Landscape and Visual – Composite and rendering analysis.

Feedback on the information supplied by the Applicant in document “Response by the Applicant on Landscape and Visual Matters” EN010122/D5/13.11

View from Twin Oak tree looking roughly South – Original photo with overlay of all new features.

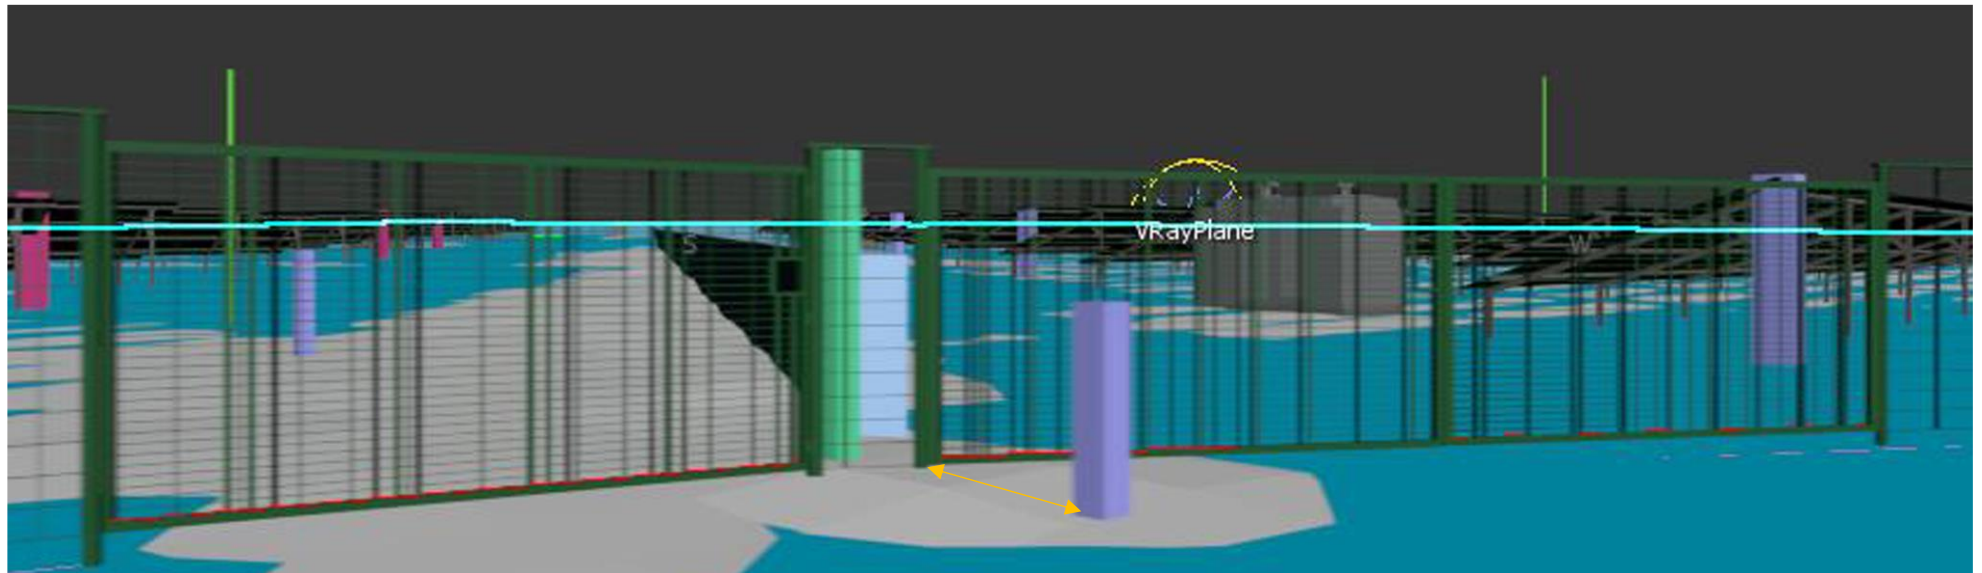
This image is now becoming rather complex, but I have included it for reference.

It can be seen on both sides of the image that the 2.7m tall solar panels (in red) barely exceed the height of the 1.6m hedge.

This again calls into question the scale (or field of view / camera position), at which the rendered model has been brought into the photograph.

View from Twin Oak tree looking roughly South – CAD model supplied for scaling reference.

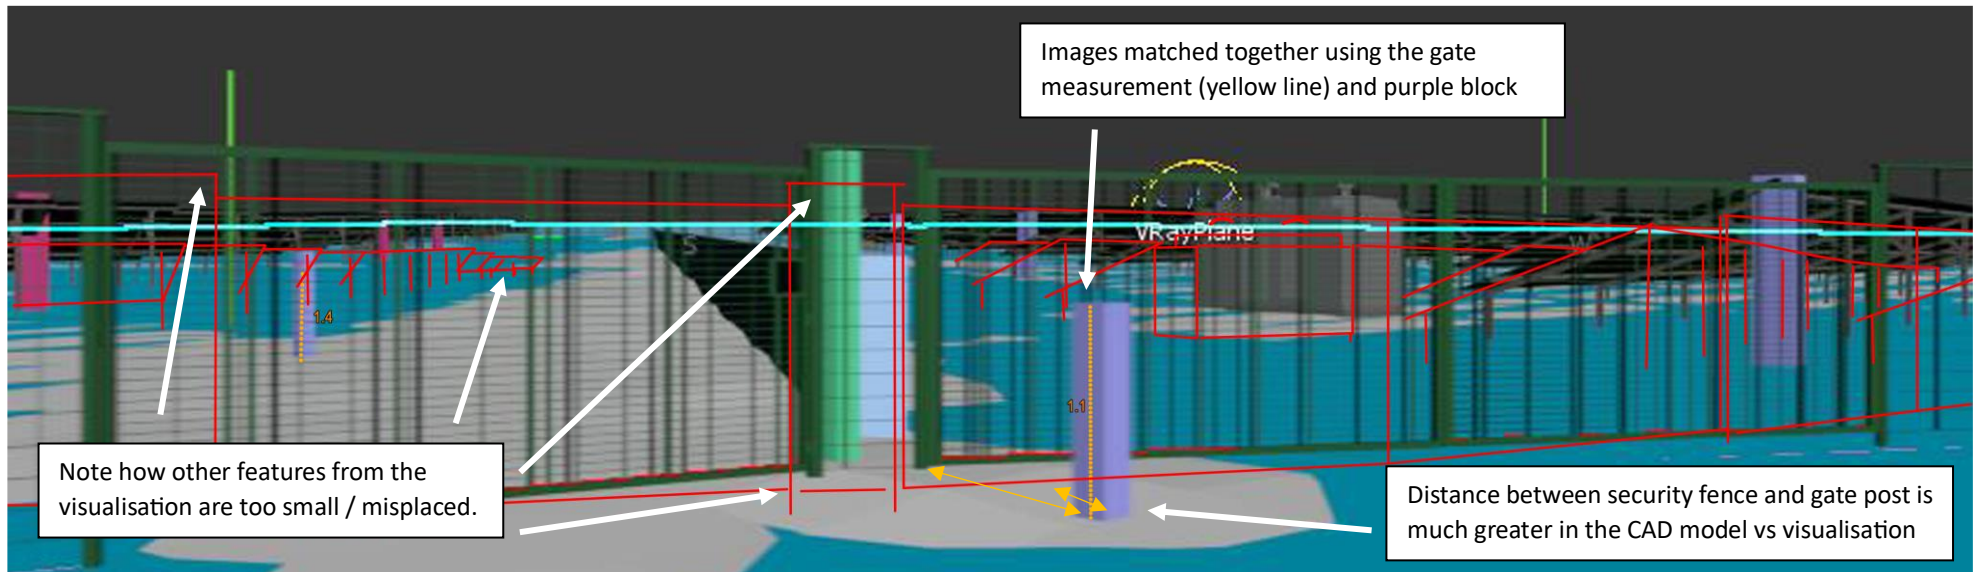
It is not clear how the Applicant has ascertained the position of the gate post in the model above as no surveys have been mentioned.

The gate post in this image is unfortunately not visible on satellite imagery, so the accuracy of positioning within the CAD model remains highly suspect.

It is quite possible that the “significantly further forward” problem with the gate post is as a result of incorrect positioning within the model. The perceived distance from the purple bar to the security fence looks much greater in this image than in the original photographs (yellow arrow).

I conclude that this image does not provide any evidence to refute my concerns with regard to the scaling and calibration.

View from Twin Oak tree looking roughly South – CAD model with tracing overlay.

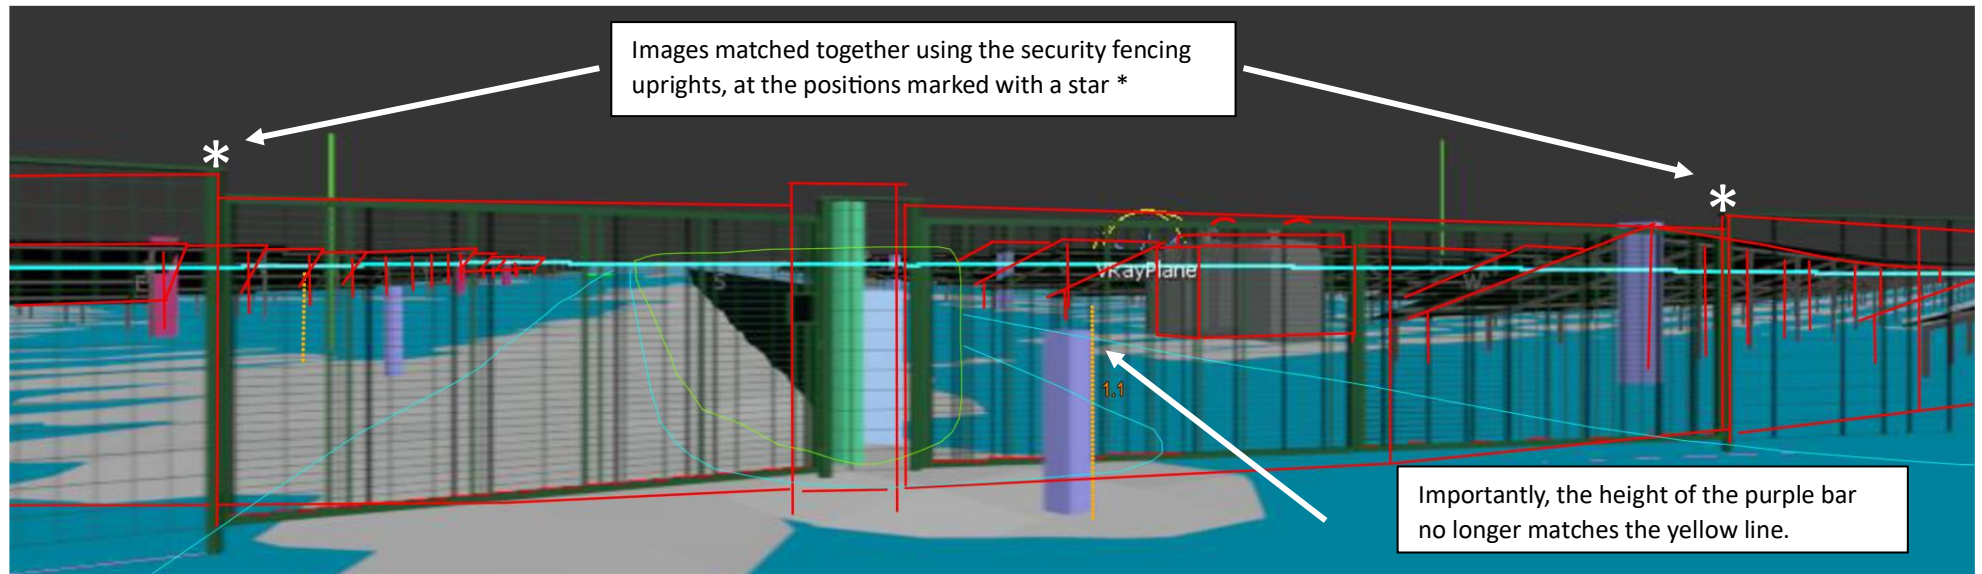
Because this view uses a slightly different camera angle from the original photographs it is exceedingly difficult to draw any meaningful conclusions.

When the traced lines from the original visualisation are overlaid onto this image by lining up the yellow line and purple block, then it can be seen that everything else is out of alignment, and much smaller than originally modelled in the visualisations.

This demonstrates just how important it is to get the correct field of view, but might also point to a problem with scaling based on an incorrect position for the gatepost in the model.

Applicants OST5 image (looking North from Twin Oak tree)

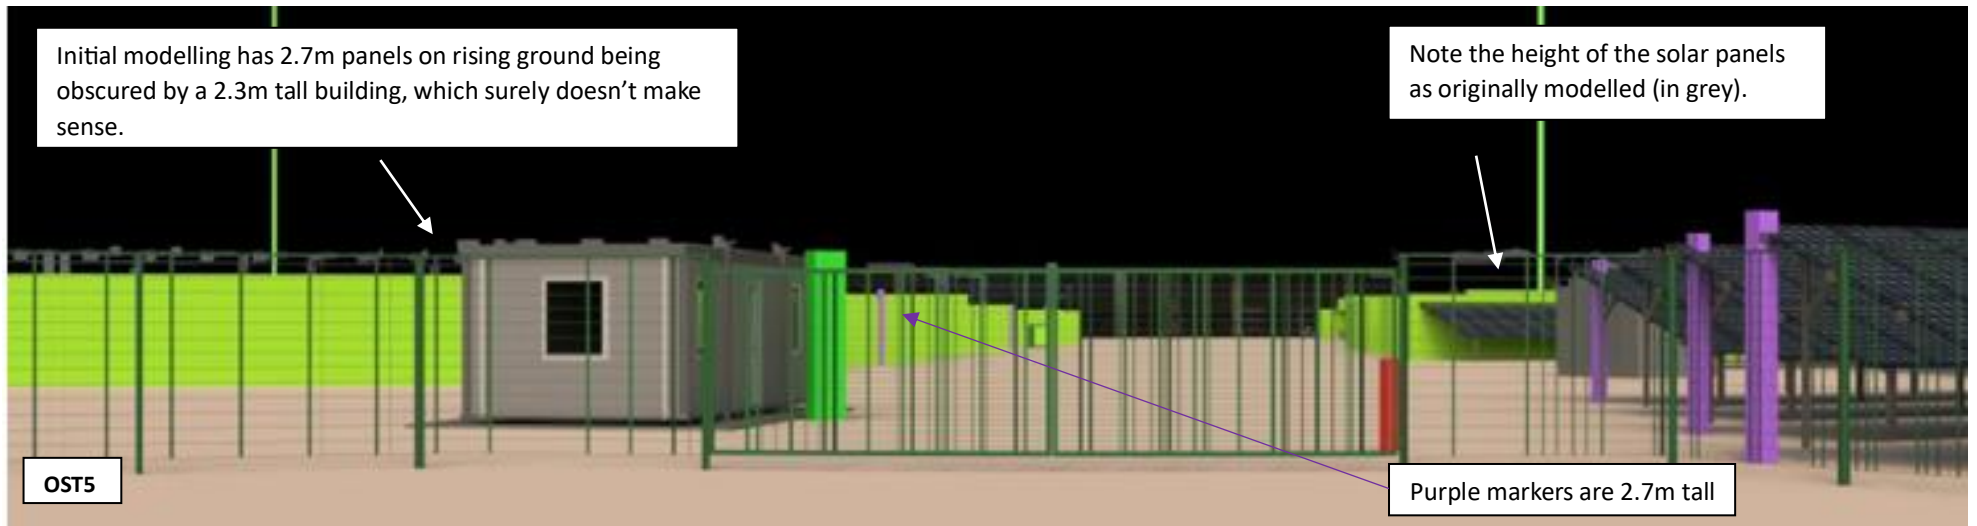
To demonstrate the difference in topography between the two datasets (Lidar and OST5), the Applicant provided some images, which I include below. Unfortunately, once again they have failed to match the camera position and field of view between these two images, so any comparisons are difficult. However, I have attempted to crop the images to be as similar as possible.

Having viewed the Applicant's supplied images (see over) it appears that visually the variance between the two sets of data might be larger than the stated 46cm, and in places might be as much as the stated RMSE for OST5. I have tried to show this on the following pages.

Applicants Lidar image (looking North from Twin Oak tree)

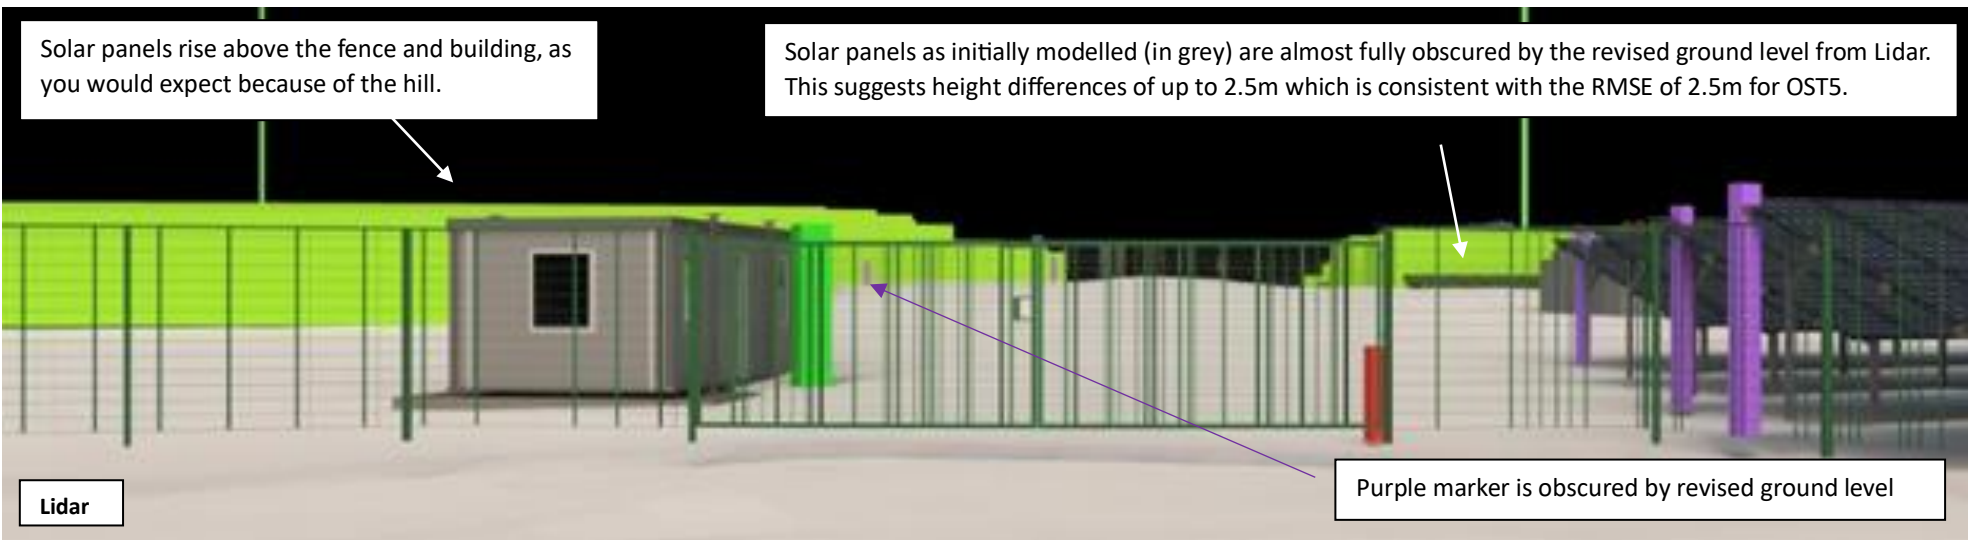
It can be seen from the images on the previous page, that the Lidar image is a more accurate reflection of the ground topography that is visible in real life. See how the horizon behind the gateway rises much higher than in the OST5 image, this is consistent with what can be seen when on site.

The purple height markers and many of the rendered solar panels from the OST5 image have ended up being obscured by the ground level in the Lidar image, to an extent much greater than the 46cm quoted by the Applicant.

I believe that it is clear from this comparison that it would have been much more accurate to model the renderings on Lidar data rather than OST5.

Applicant's original visualisation (looking North from Twin Oak tree)

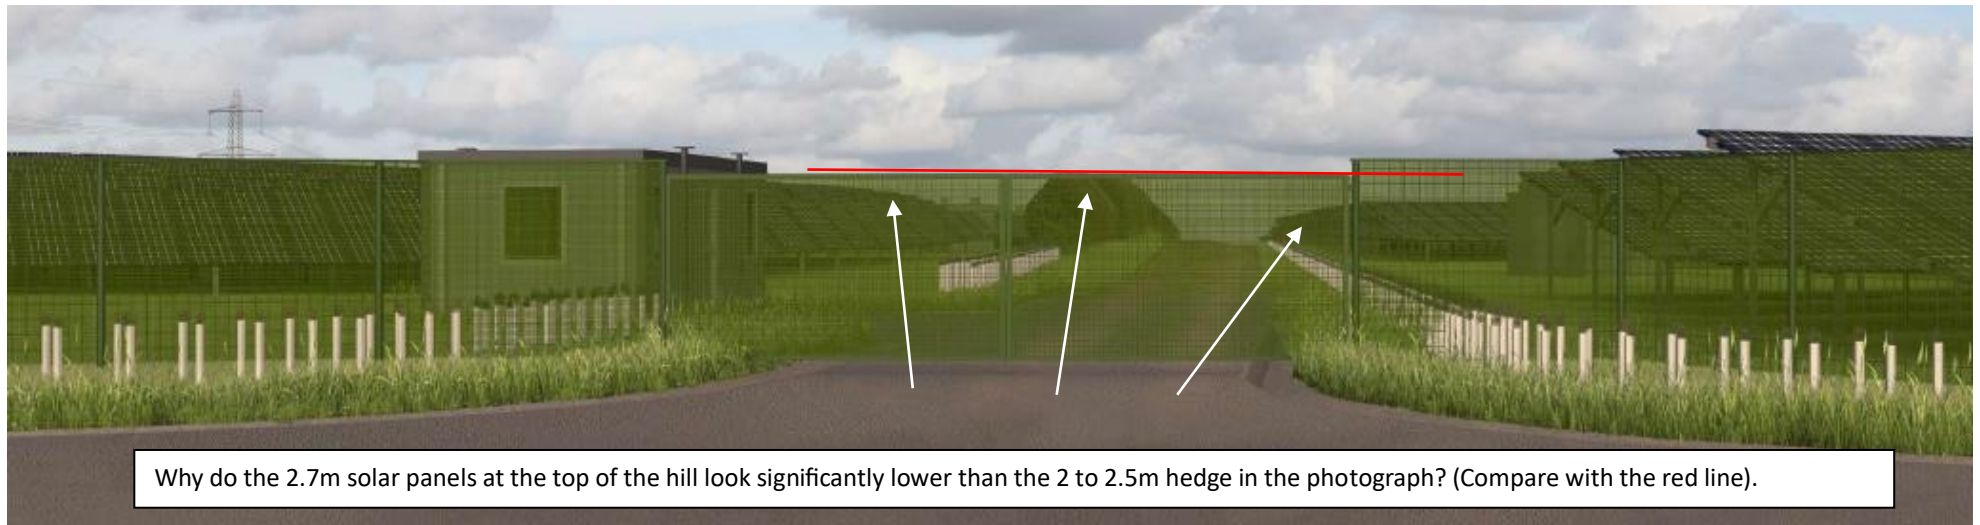
The image below clearly shows this: why are the 2.7m tall solar panels modelled at only a fraction of the height of the hedge at the top of the hill? (The hedge is estimated to be approximately 2 to 2.5m tall).
